Revised Implementor's Guide for the ITU-T H.320 Recommendation series (H.221, H.224, H.230, H.242, H.243)

This document is a text revision of the Implementor's Guide for H.320 series recommendations. Changes are made against the 05/99 revision of H.221, H.230 and H.242, and the 02/2000 revision of H.224 and H.243.

Implementor's Guide for the ITU-T H.320 Recommendation series - Narrow-band visual telephone systems and terminal equipment

7.4.3.2 Section III.3 - Mode switch to non-standard mode using MBE command

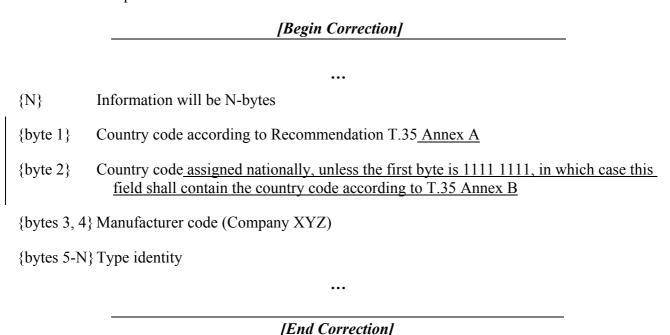
Section III.3 is updated as follows:

7.5.3 Editorial corrections to section 2/H.243 – References

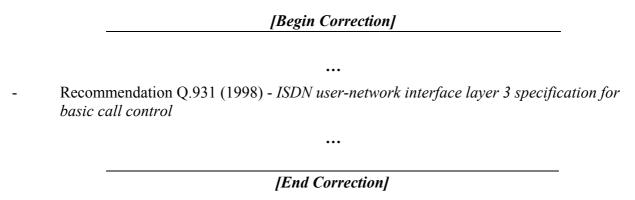
While it has not been added previously, a reference to Q.931 is now being added to the list for completeness as follows:
